# LAND OFF OAKHURST RISE, CHELTENHAM

## ARBORICULTURAL REVIEW

**Land at Oakhurst Rise, Charlton Kings**  
**Outline application for up to 69 dwellings, including access, layout and scale**  
**Reference 18/02171/OUT**

**RESPONSE TO HERITAGE AND CONSERVATION COMMENTS**

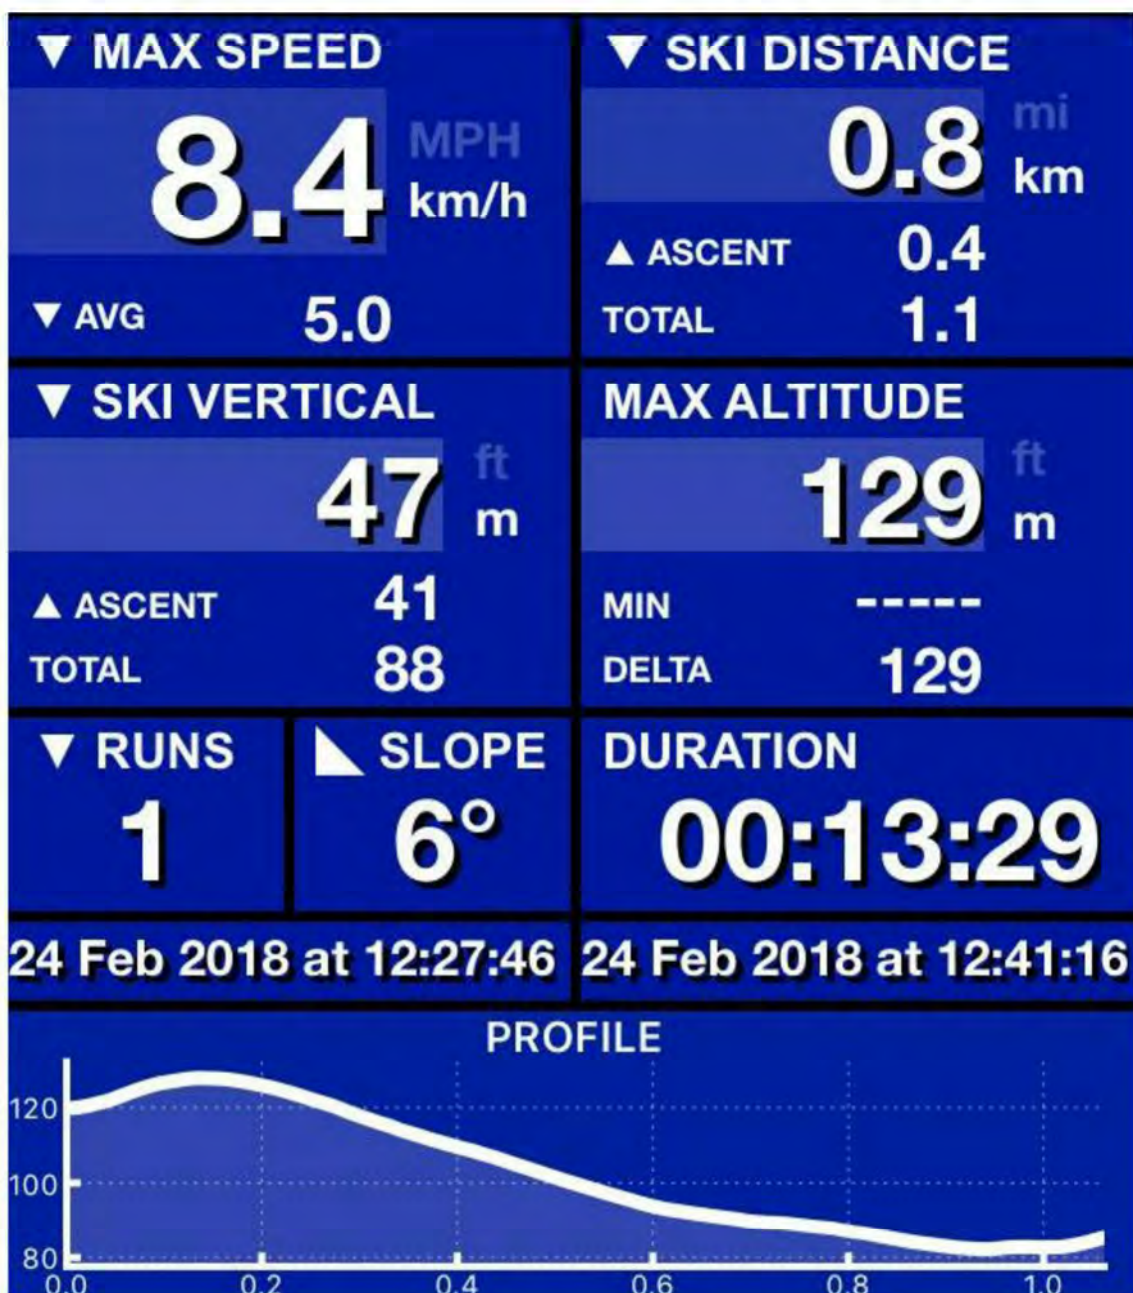
We sent a 15 year old double county athletics champion around the proposed layout, ensuring he was walking at a pace above that claimed in the plan (despite the 1:11 climb in places).

The attached are his tracks off a skiing app which measures time and altitude. For the avoidance of doubt, the walk is 1100 metres. **It took him 13.29 minutes to walk there, 14.28 minutes to walk back. [This is outside of the government recommended walking and cycling distance for local amenity].**

Please can you add the appropriate error margin to all the transport data - it under estimates all distances by at least 20%, and all times by an error margin of 33%
